Flying Horse North – Phase 2 PUD Parcels 1-6 Preliminary Drainage Report

November 2023

PCD File No. PUD-XXXX **PUDSP234**

**EPC STORMWATER REVIEW COMMENTS
IN ORANGE BOXES WITH BLACK TEXT**

Figure 2: Existing Tract L Irrigation Pond and Reservoir

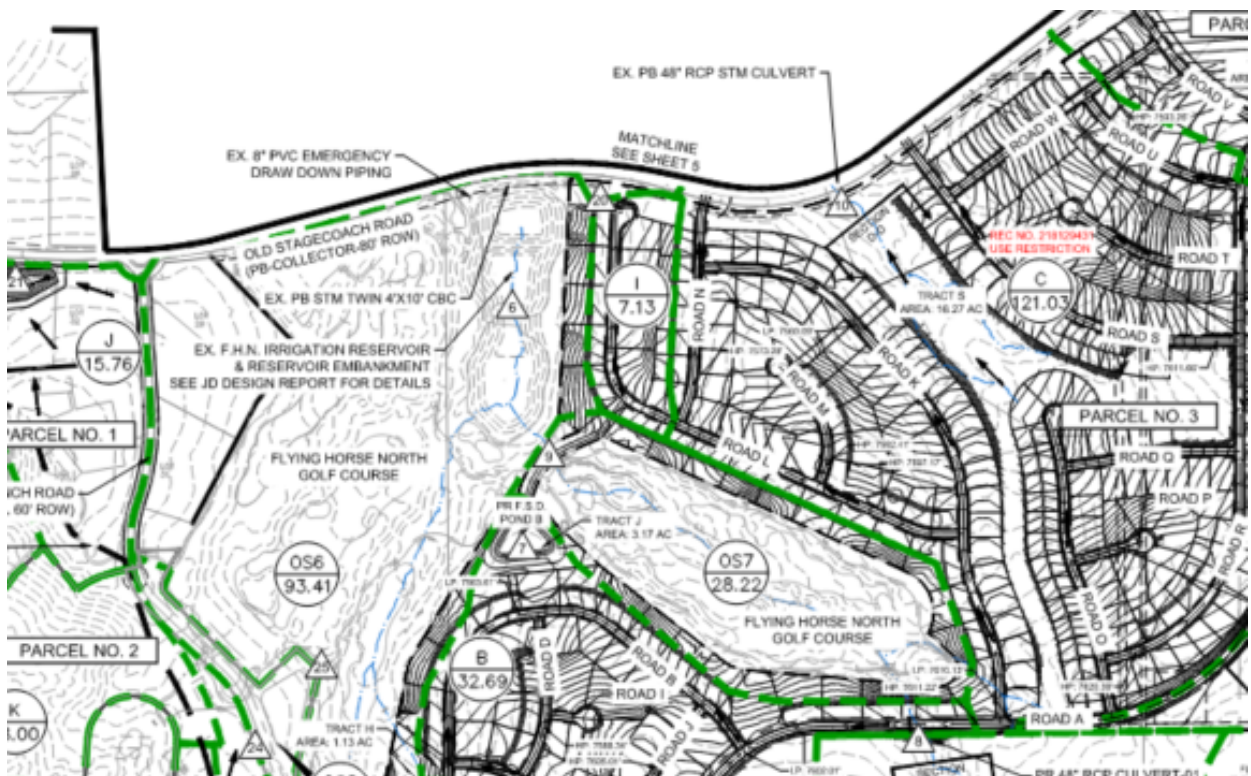
please clarify if the irrigation reservoir is providing detention and water quality for this and any other basin.

please be address the rear lots that are within OS6 and OS7 as these will also require water quality treatment. Assumption is that the irrigation Reservoir will provide treatment. Please clarify.
